# P 61 092 SUPERSEDED BY P 23 144

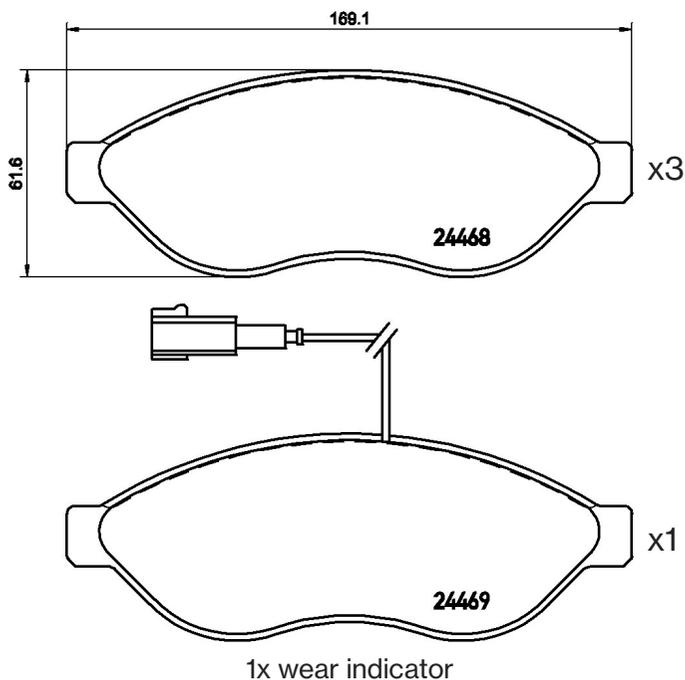
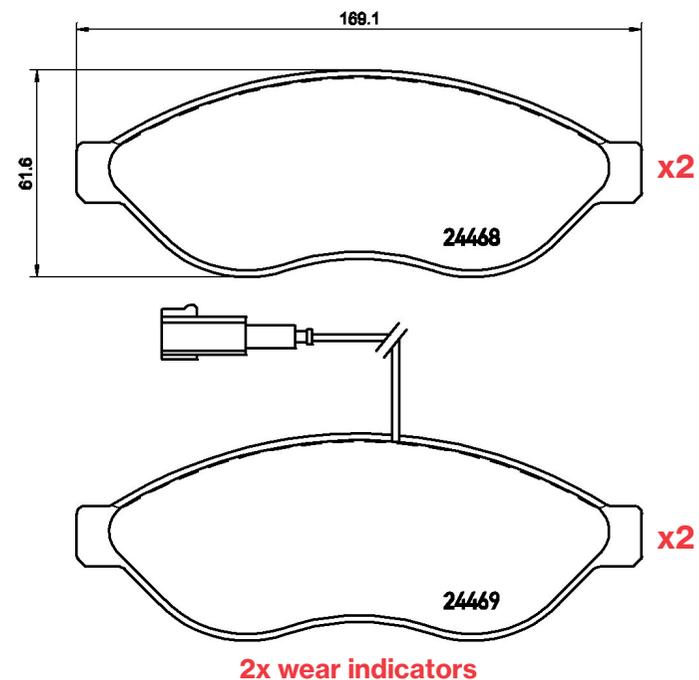
For the reference P 61 092, Fiat changed the corresponding OES references from one wear indicator to two wear indicators per set. Wear indicators not used have to be simply cut off during assembly. Brembo will perform the same change, according to the OES programme. P 61 092 will be replaced by P 23 144.

Existing stock of P 61 092 can be sold out. Please used only on vehicles equipped with one wear indicator.
